FILE STP-218-1(1) Chatham County **OFFICE** Preconstruction
P. I. No. 522790
DATE May 16, 1997

SUBJECT PROJECT CONCEPT REPORT APPROVAL

SUBJECT **Proposed Project Concept Report**

PROJECT CONCEPT REPORT
CHATHAM COUNTY
STP 218-1-(001)
JIMMY DELOACH PARKWAY, PHASE II

FROM
 U.S. HWY 80 TO I-16
 RURAL SECTION W/13.6m DEPRESSED MEDIAN

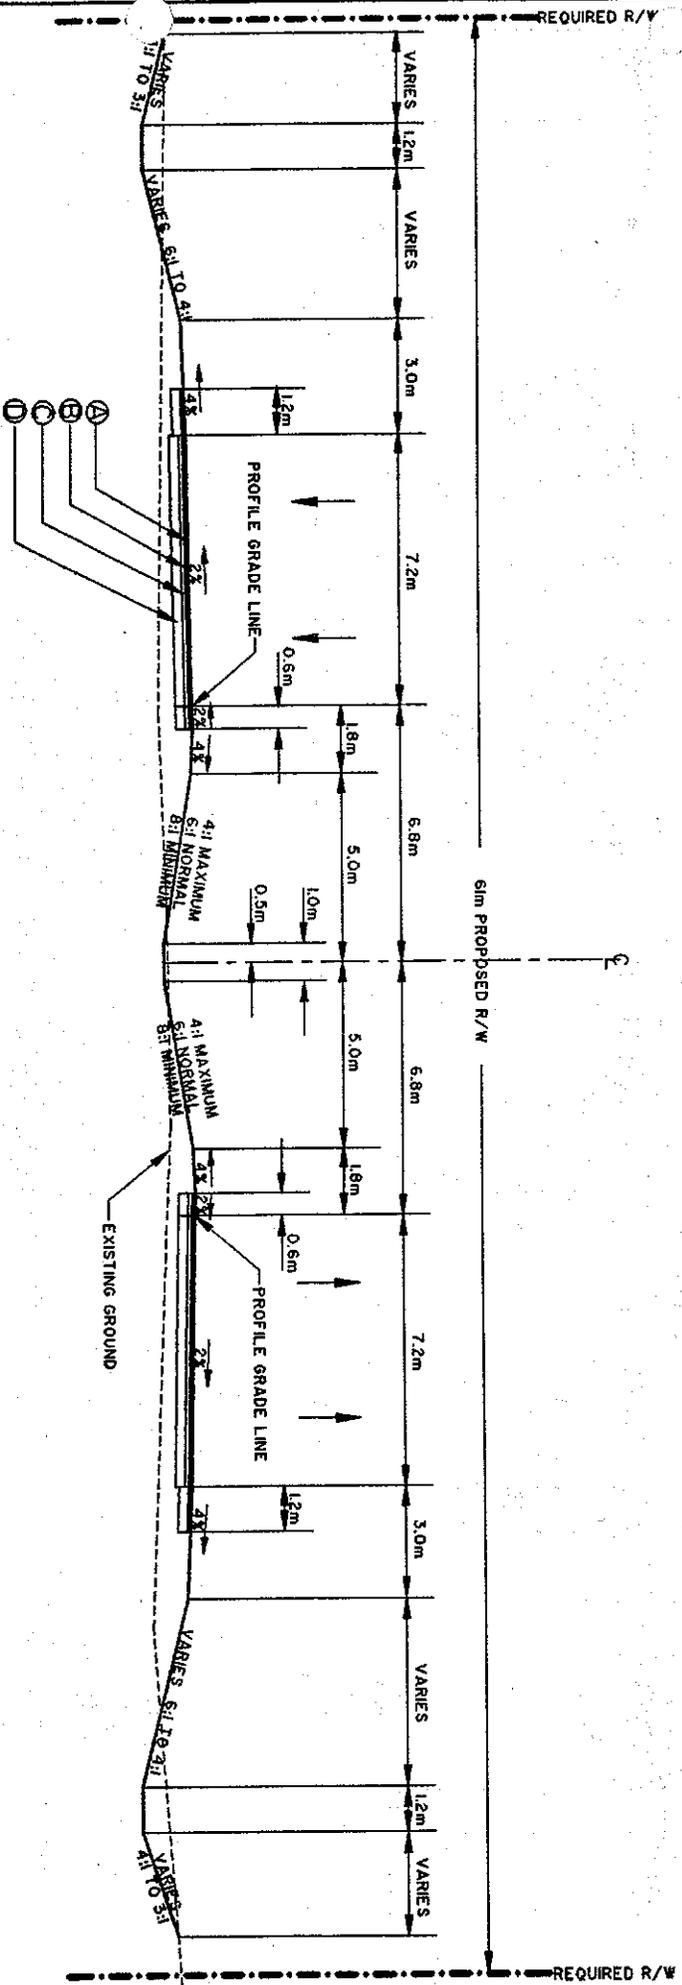
The 0.6m (2') shoulder on the inside of the typical section should have the same pavement thickness as the mainline.

The concept report needs to include proposed median cuts with an emphasis on high traffic areas. The minimum spacing between median breaks should be 400m (1320') but the desirable spacing would be 800m (2625').

Straight tapers are acceptable for median transitions. Use the formula $W*L*0.6$ to determine the metric taper length (The formula $W*L$ is used to determine the English taper length). It is more desirable to transition in a curve if possible.
